TENNESSEE VALLEY AUTHORITY

CONTINUOUS ONLINE NUCLEAR ANALYZER OF COAL (CONAC) BYPRODUCT MATERIAL
LICENSE APPLICATION CONTROL NO. 81-97

As discussed in the telephone conversation between Gary R. MacDonald of my staff and you on February 17, enclosed is information needed to answer questions you raised while reviewing the CONAC byproduct material license application.

Photo 1

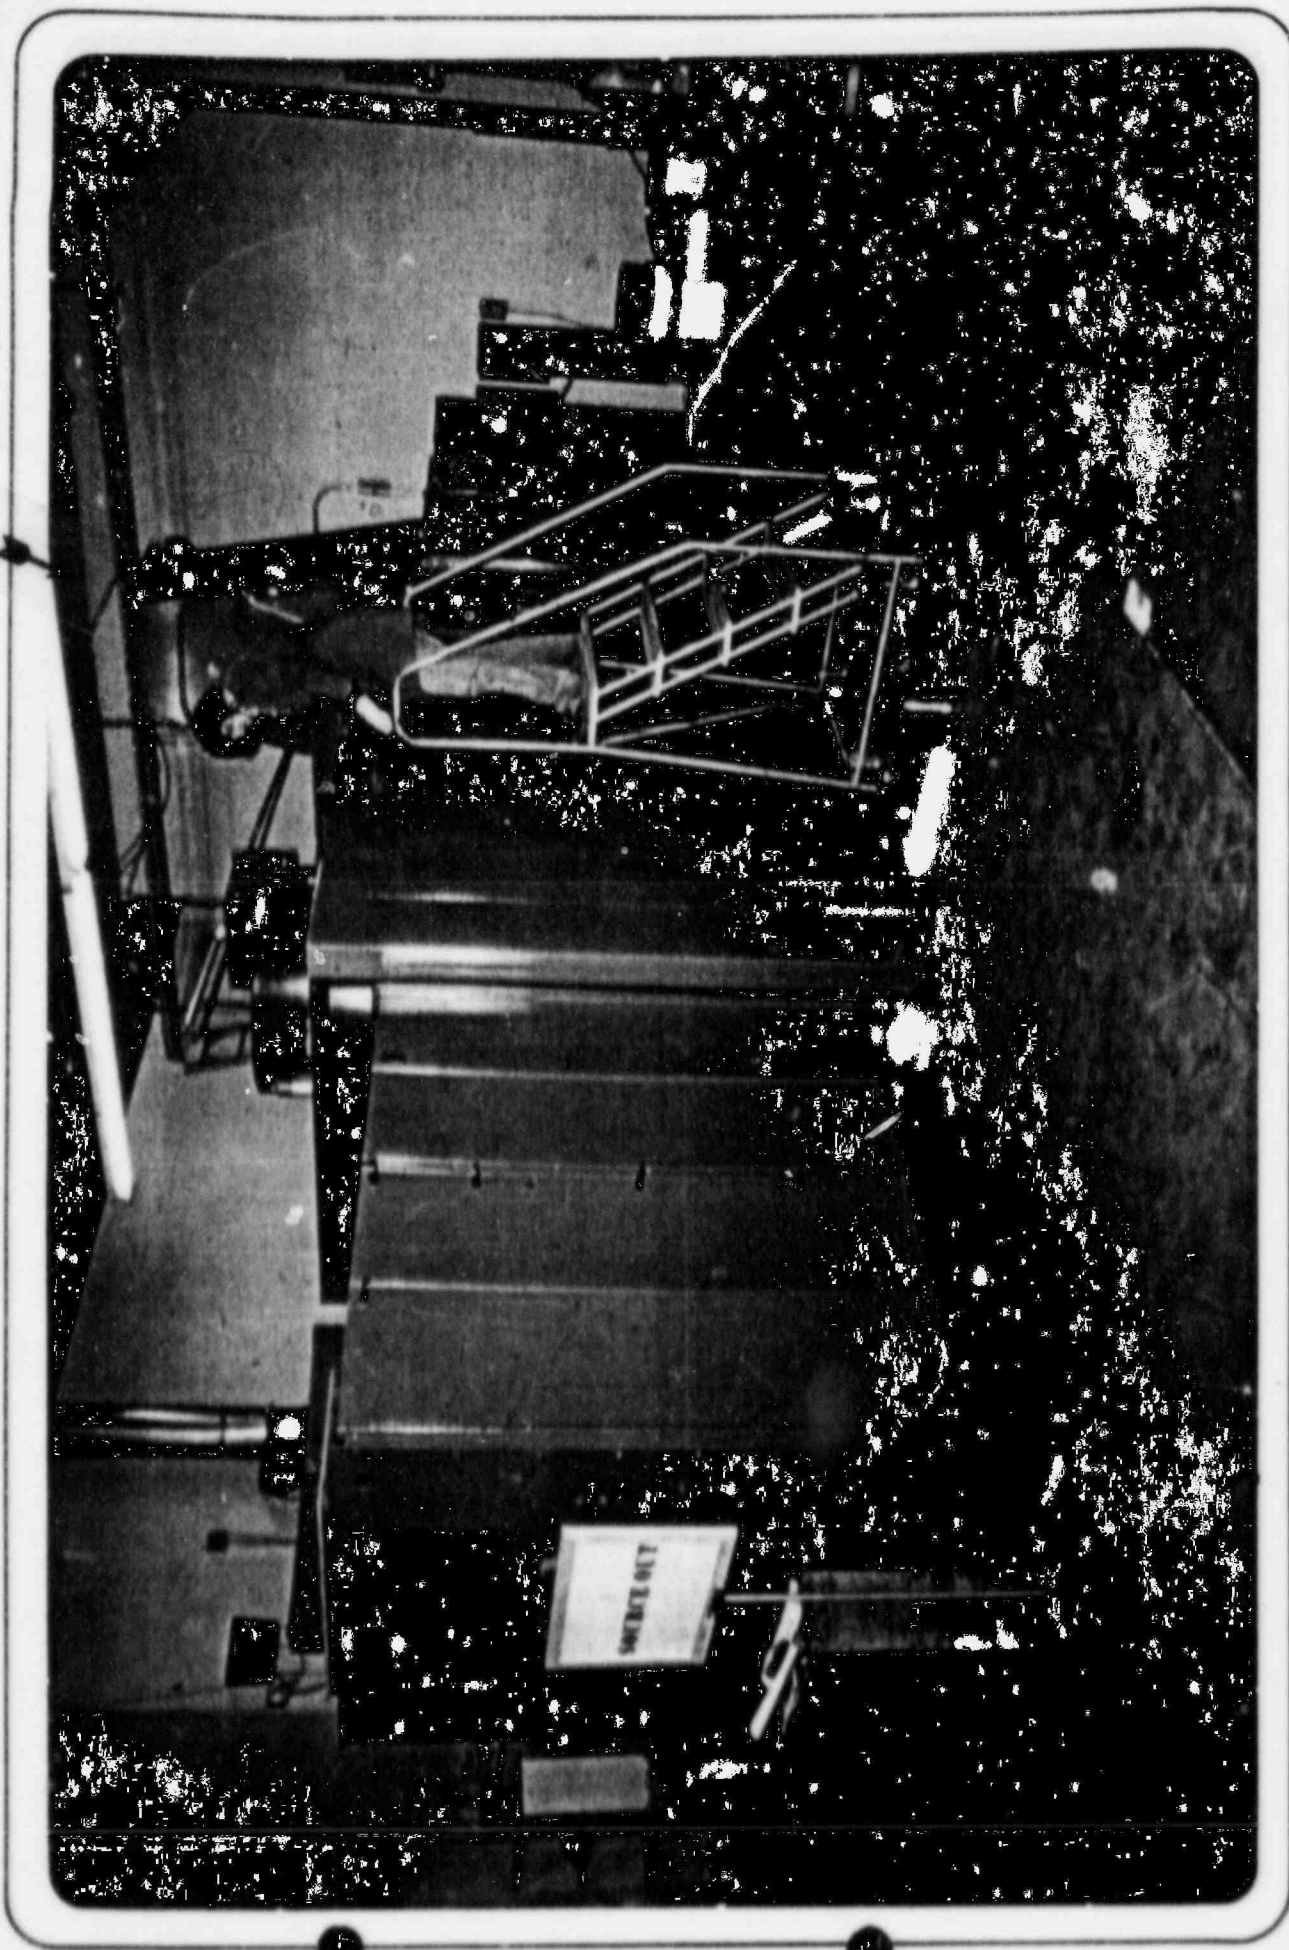
- legible dwgs with materials of const / dimensions
- Narrative description of device and photos.
- He told me the unit will be installed in the same room as the RSM (our control C 81-81) thus environmental factors will be the same.
- ASK^{ed} for clarification of the SR model designation SRCL (1902) no info in our files
- He told me the unit has been built and is now undergoing tests in California by SAJ

Narrative and Photo Description—Enclosed are two photos to aid in visualizing the CONAC. Photo No. 1 shows a full view of the CONAC. It measures 25 feet long by 14 feet high at the input hopper and weighs approximately 14 tons. As indicated in the conceptual drawings sent with the original application and pictured to the right in Photo No. 1, coal enters the system through the input hopper and is gravity fed and leveled to an uniform depth by an adjustable gate. The coal is then measured for moisture content by conveying the coal on a moving belt past a microwave moisture meter. Coal flow rates are derived from the mass sensor monitor which uses a standard density gauge with a tachometer located next to it. Adjacent to the tachometer is the Californium-252 source module (center, Photo No. 2). The coal is irradiated by neutrons emitted by the Californium from beneath the belt, and the gamma ray detectors are positioned above the source and coal. These gammas are sorted by energy using a multichannel analyzer. A computer then determines coal constituent analysis.
